Objection Notes

Date	15 December 2025
Project	11-23 Rangers Avenue Mosman
Project No.	2520
Resident Address	16 Holt Avenue Mosman
Resident Applying for Objection	Sonni Jeong

HEIGHT PLANE DIAGRAM - SOUTH-EASTERN CORNER

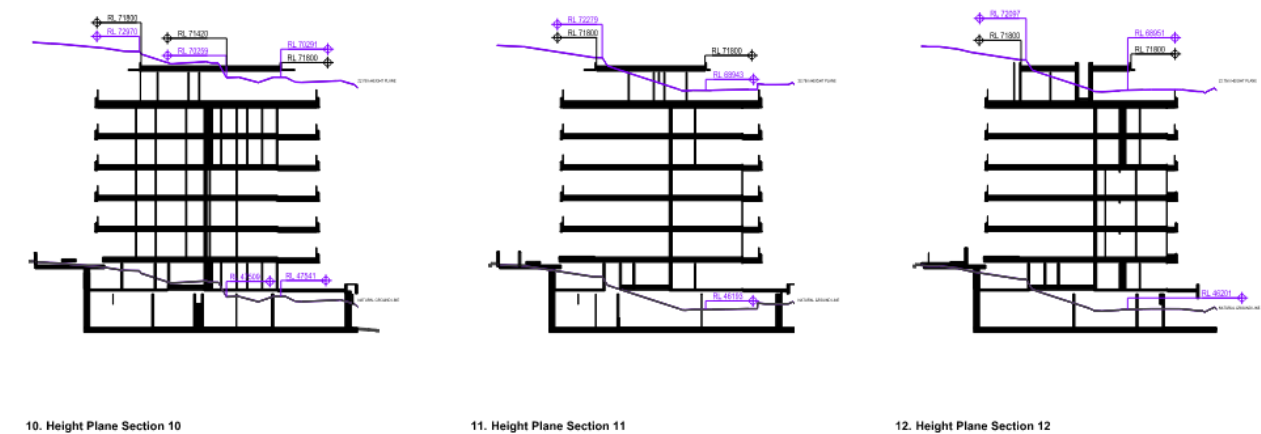
As shown in the Woods Bagot DA architectural drawings, the proposed building exceeds the height plane at the eastern corners, noting that this height plane is already set at 30 per cent above the maximum permissible building height. This excessive height is inappropriate in the local context and results in a dominant blank wall presenting to the adjoining property at 9 Rangers Avenue, Mosman, which is only two storeys in height when measured from Bloxome Lane.

5. Lack of Buffer Zone between R3 and C4 Zones

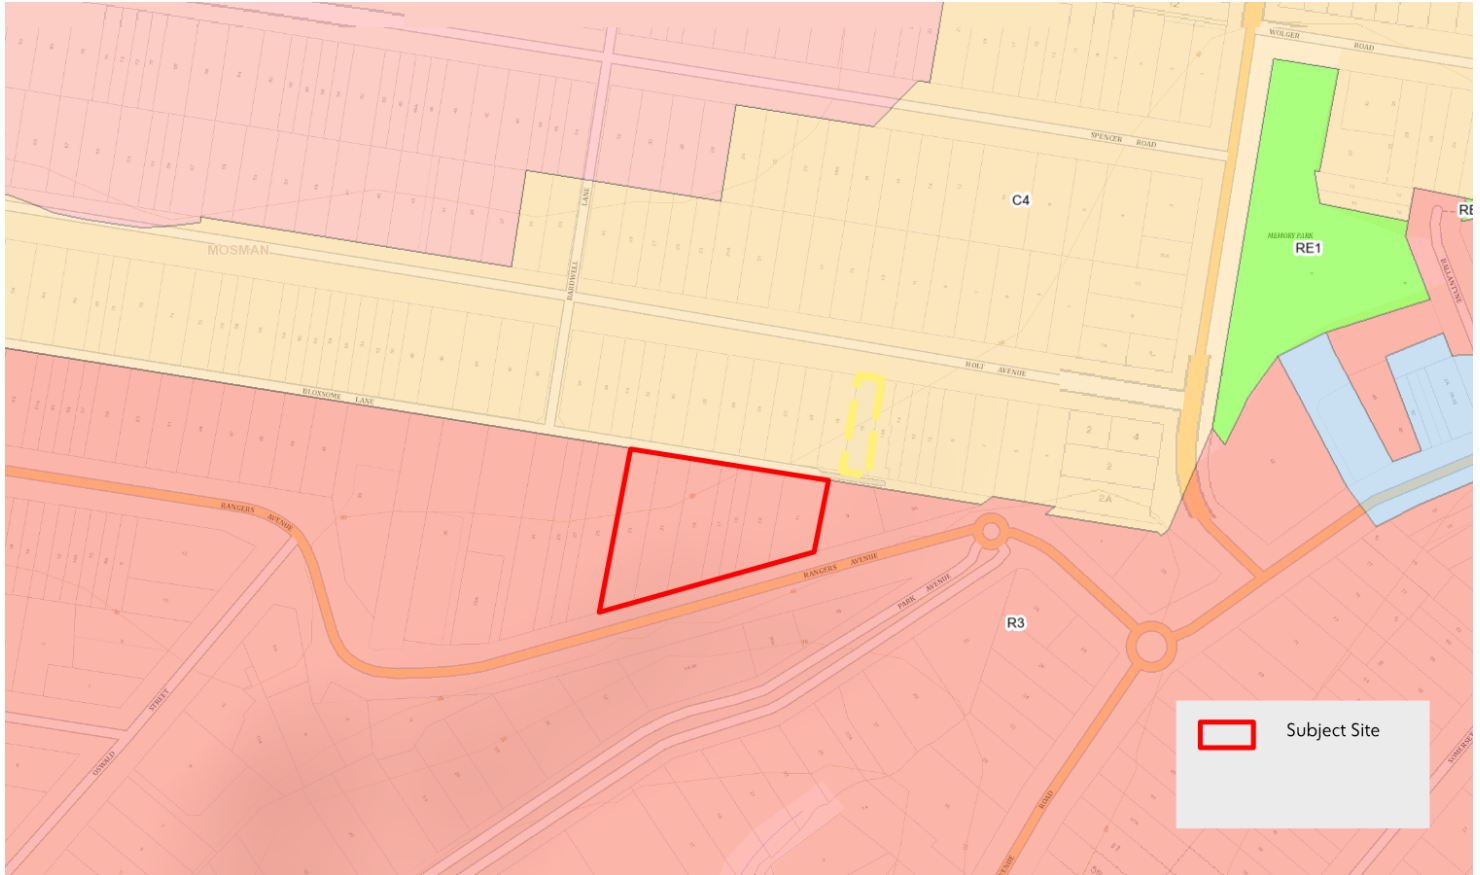
The absence of a clear height “buffer” or transitional control between R3 Medium Density Residential and C4 Environmental Living zoning in Mosman can undermine the intent of nearby heritage conservation areas, with a focus on the Holt Avenue streetscape within the Holt Estate Heritage Conservation Area. It draws on the Mosman LEP 2012 written instrument, LEP maps, and the Holt Estate heritage survey.

The issue is that this framework is still largely a single-number cap per site, and it does not inherently create a graduated interface at a zone boundary. Where the mapped heights are the same (or close) on both sides of an R3/C4 edge, there is no mapped step-down or “transition strip”, so the boundary can function as a hard line rather than a designed change in scale.
